GRIDER CORNER SUBDIVISION

APPLICATION NUMBER 4 DATE November 6, 2014

REQUEST Subdivision

DETAIL SITE PLAN

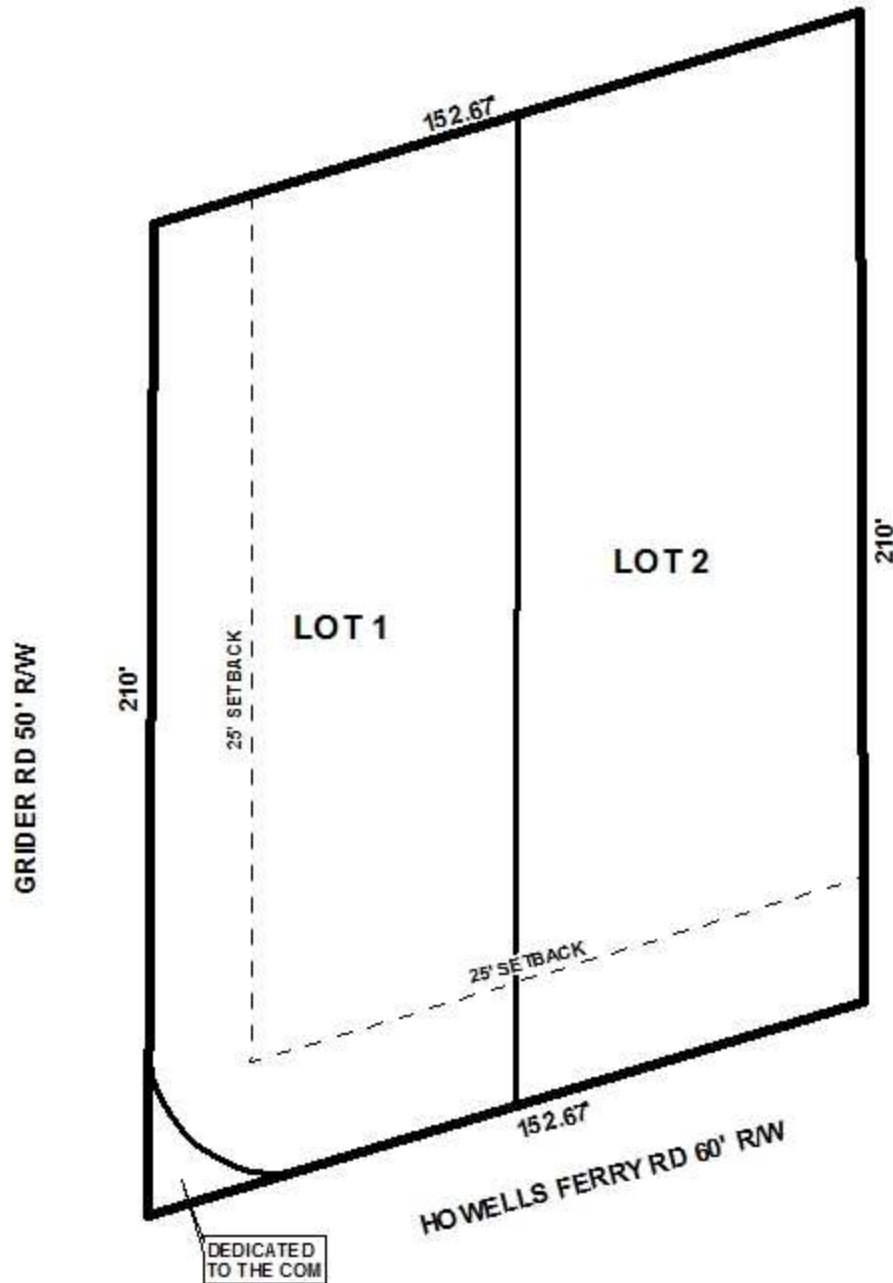
- D. Show and label all flood zones.
- E. Provide and label the monument set or found at each subdivision corner.
- F. Add a signature block for the Owner, Notary Public, Planning Commission, Traffic Engineer, and City Engineer.

The preliminary plat illustrates the proposed 2-lot, 0.7± acre subdivision which is located on the Northeast corner of Howells Ferry Road and Grider Road, and is in Council District 7. The applicant states that the subdivision is served by city water and an individual septic system.

The purpose of this application is to create 2 legal lots of record from two metes and bounds parcels totaling 17.9 ± acres. The remaining 17.1 ± acres are labeled future development and currently contain an existing dwelling unit; however, the applicant has stated that the house will be moved onto the proposed Lots 1 and 2, but did not specify which specific lot.

In accordance with the Subdivision Regulations, as proposed, both proposed lots would comply with the minimum lot size requirements of Section V.D.2. of the Subdivision Regulations, which in this case is 15,000 square feet due to the proposed use of individual septic systems.

It should be pointed out that as the site fronts Howells Ferry and Grider Roads, both minor streets without curb-and-gutter. The existing right-of-way width for Halls Mill Road is compliant and therefore, no additional dedication would be required along this street. The right-of-way width for Grider Road is depicted as 50'; however, the Subdivision Regulations require a 60' right-of-way width for minor streets with no curb-and-gutter and, as such, dedication sufficient to provide 30' from centerline would be required for the proposed Lot 1 along Grider Road. It appears that other recent subdivisions along Grider Road have not been required to dedicate any additional right-of-way, thus a waiver of Section V.B.14. of the Subdivision Regulations may be appropriate. It should be noted that if dedication of right-of-way is required, the lot size of proposed Lot 1, in terms of area, may fall below the minimum area required for lots with public water and individual septic systems.

GIS data depicts a portion of the Future Development area within wetlands due to the presence of an existing stream. The proximity of the site to water may mean that the site is environmentally sensitive, thus approvals from local, state and federal agencies for streams wetland issues may be required prior to development. A note regarding this requirement should appear on the Final Plat, if approved.

Based on the preceding, and with a waiver of Section V.B.14. for right-of-way dedication along Grider Road, this request is recommended for Tentative Approval, subject to the following conditions:

- 1) Relocation of the existing residence to one of the proposed lots, with appropriate permits, or removal/demolition of same, prior to the signing of the final plat;

- 2) Placement of a note on the plat stating that each lot is limited to one curb-cut, with the size, design, and location to be approved by Traffic Engineering and conform to AASHTO standards;

- 3) Labeling and depiction of the future development area on the final plat;
- 4) Each lot to be a minimum of 15,000 square feet;
- 5) Compliance with Traffic Engineering comments (*Each lot is limited to one curb cut, with size, location and design to be approved by Traffic Engineering and conform to AASHTO standards.*);

- 10) Placement of a note on the plat stating that approval of all applicable Federal, state and local agencies is required for wetland and flood zone issues, if any, prior to the issuance of any permits or land disturbance activities.
